MONITORING REPORT (MY1)

ARABIA BAY WETLAND MITIGATION SITE

Response to IRT Comments – As-Built and Baseline Monitoring Document

**Arabia Bay Wetland Mitigation Site
 Mit Plan Monitoring Device Location VS
 As-Built Location**

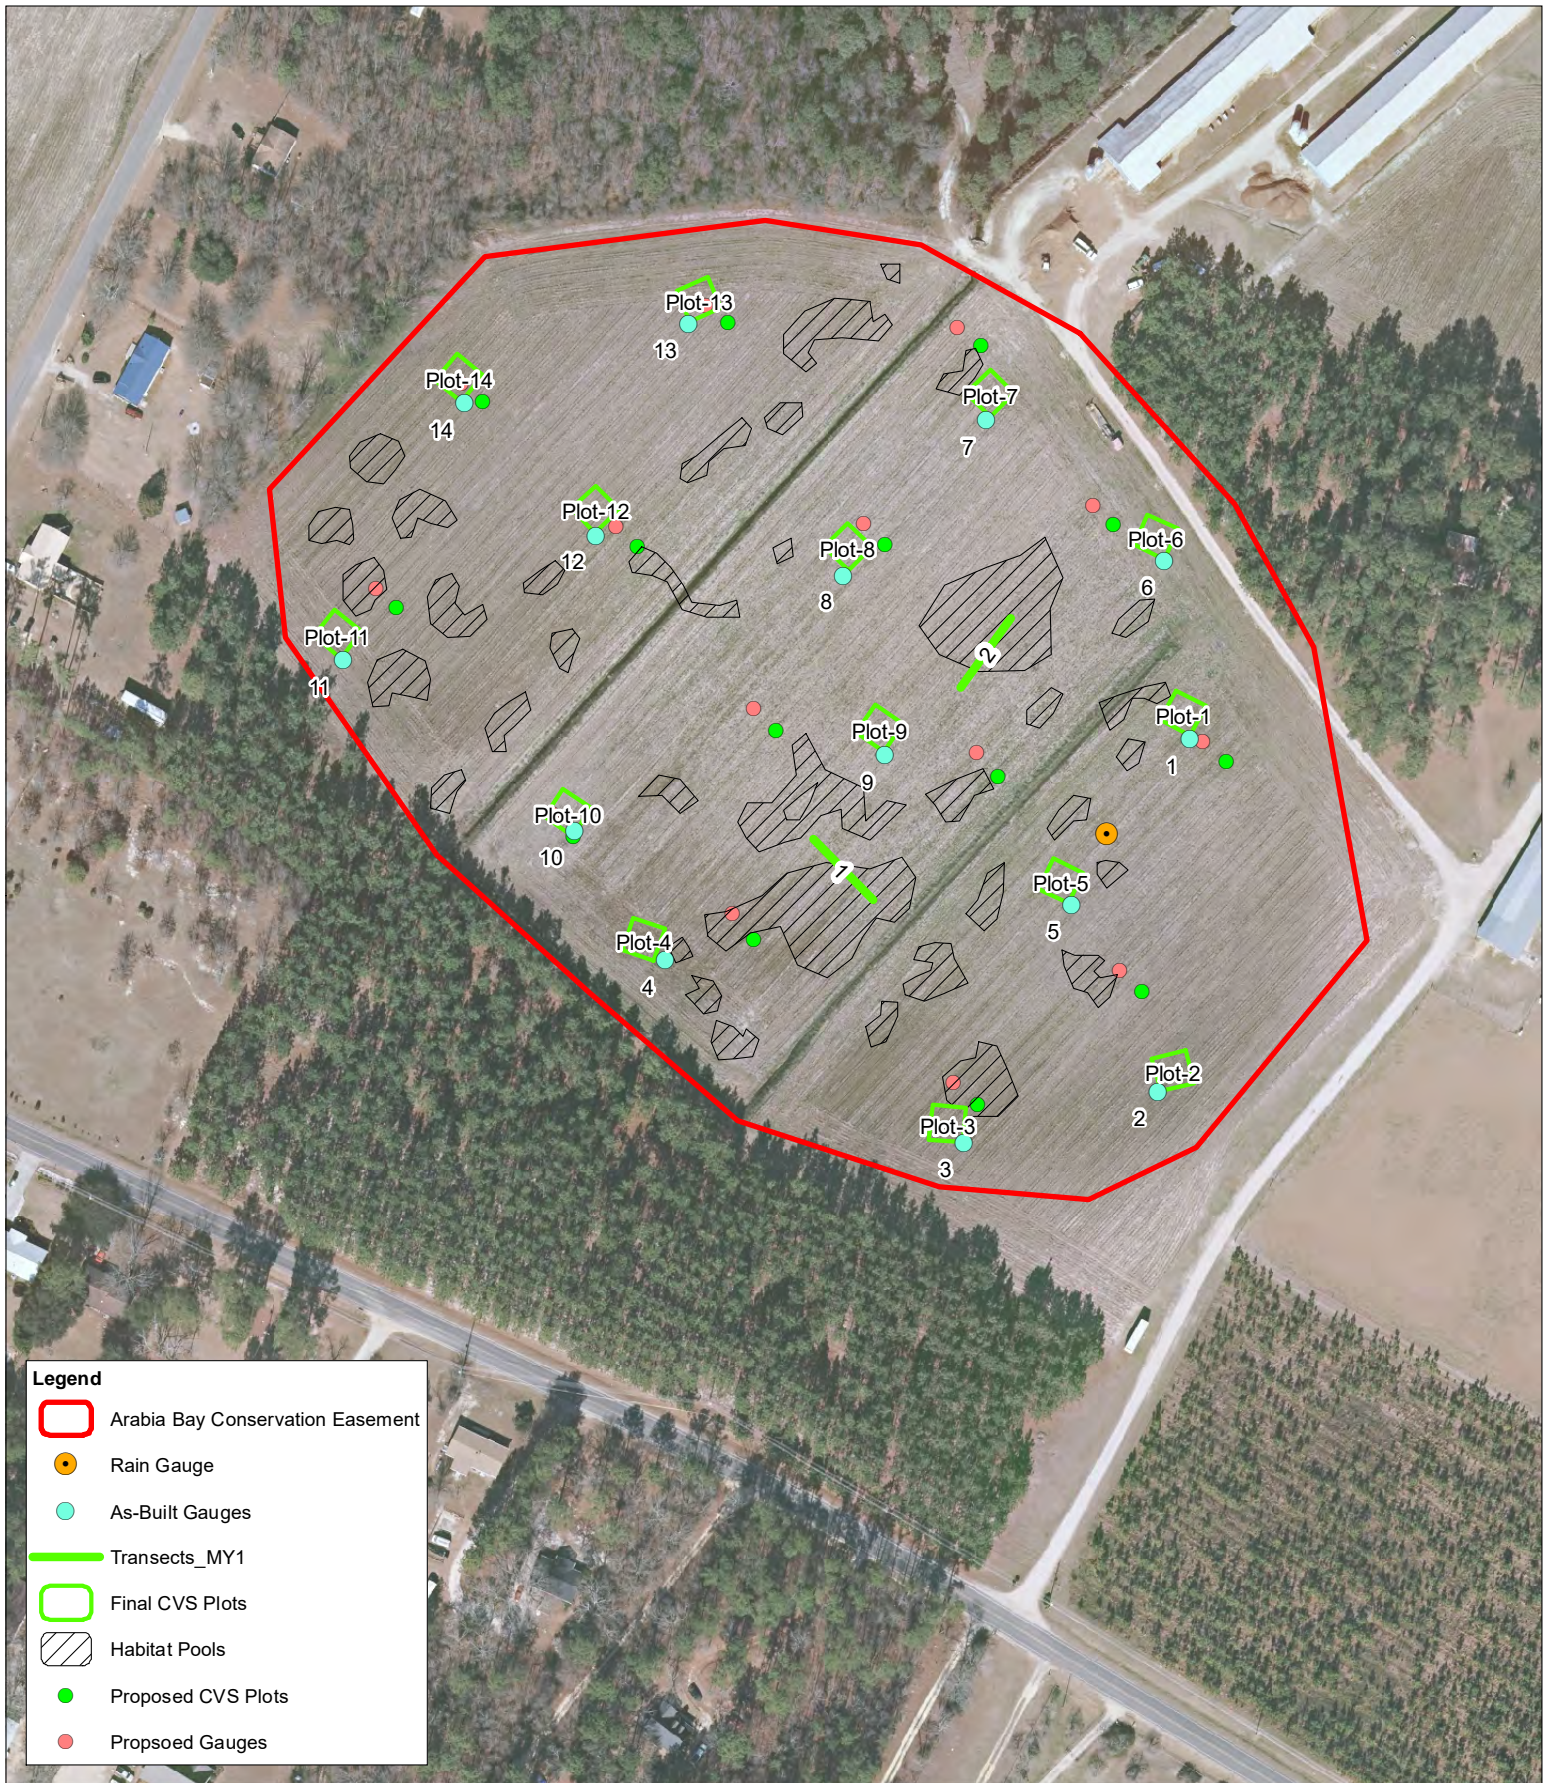
- c. Particularly for wetland restoration projects, it would be helpful to note if there are shifts (more than just a few feet) in monitoring locations (veg plots and wells) from the final monitoring plan.

[Understood – See Figure below comment responses "Arabia Bay Wetland Mitigation Site Mit Plan Monitoring Device Location VS As-Built Location".](#)

CURRENT CONDITIONS PLAN VIEW

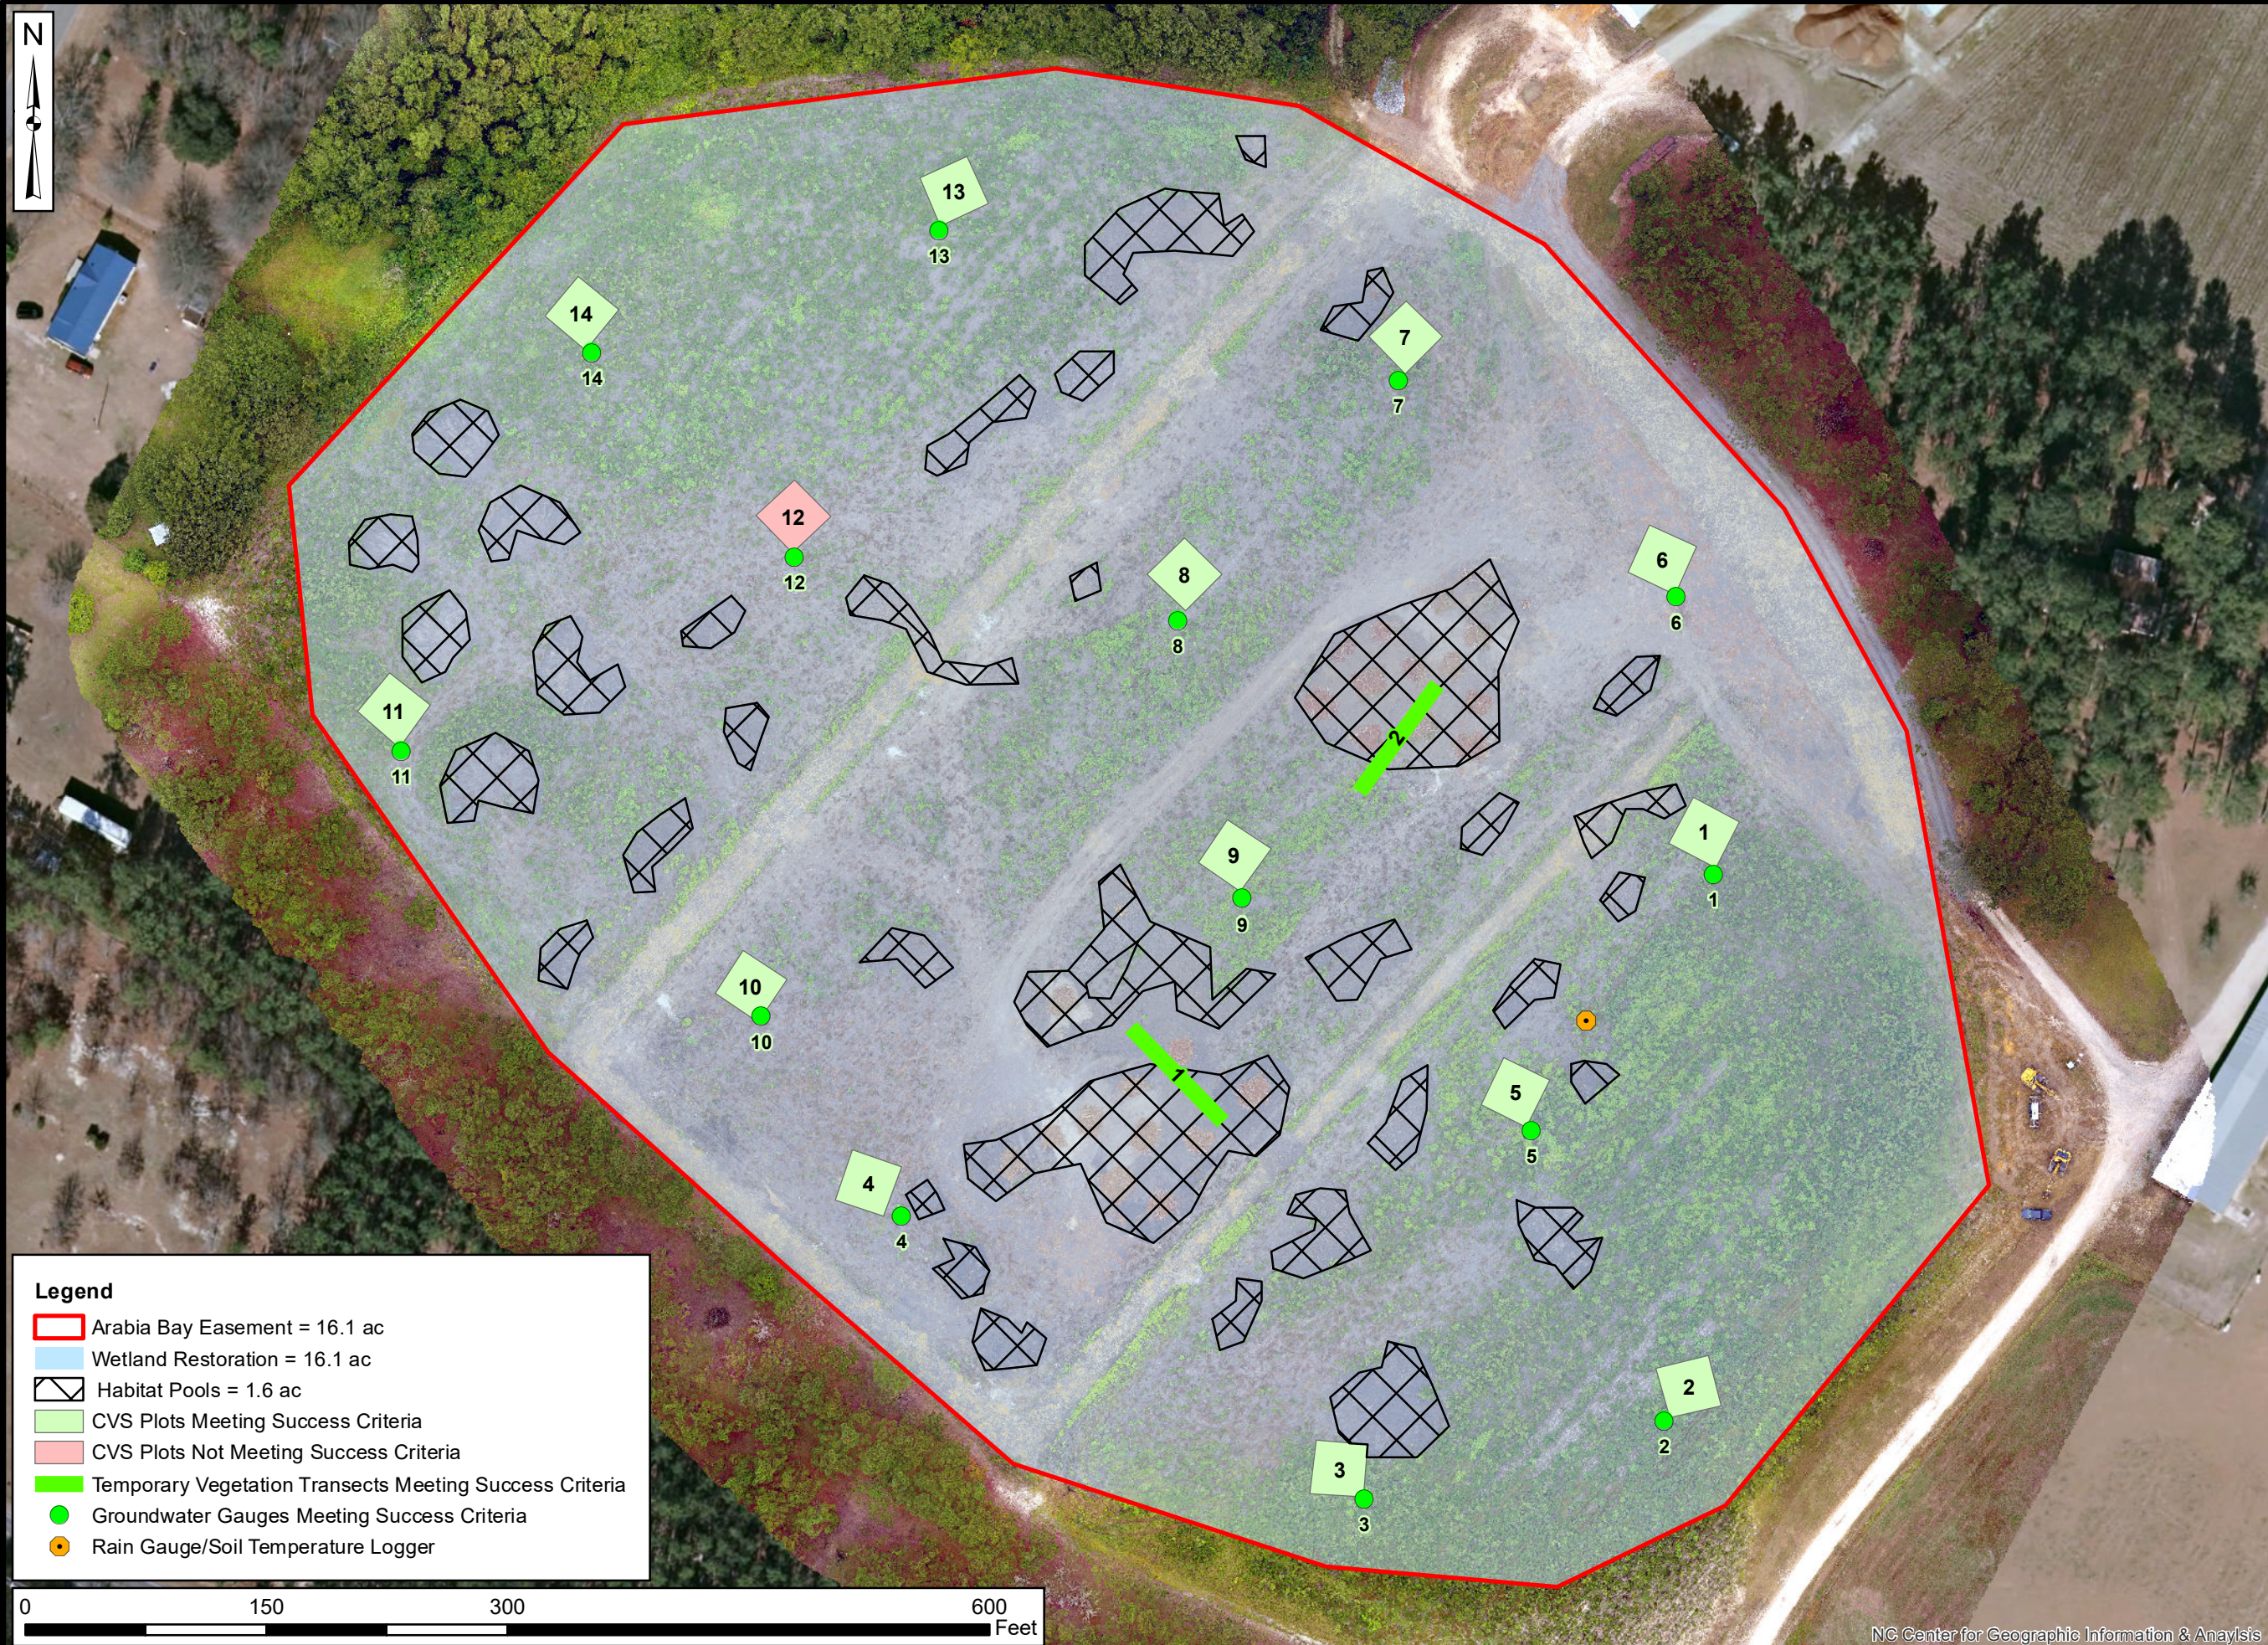
These dates have been added to Table 2, located in the Monitoring Summary and within Appendix A.
4. Figure 2 –
 - a. Please confirm whether the total area of habitat pools is 1.6 acres (Fig. 2) or 1.8 acres (Sheet 3 of 4).

The discrepancy between 1.6 and 1.8 acres results from the surveyor applying a polygon simplification algorithm to their work, which softens the lines seen in Figure 2. Figure 2 shows the actual surveyed points of the habitat pools.
 - b. The location, size and quantity of habitat pools appear notably different from that presented in the final mitigation plan. The mitigation plan showed 14 pools located primarily around the perimeter of the restoration area. Figure 2 show 36 smaller pools, with the larger pools located near the center of the restoration area. DWR understands that some variability with size and location of pools from mit plan to as-built is expected, but would like a brief explanation for these construction field changes.
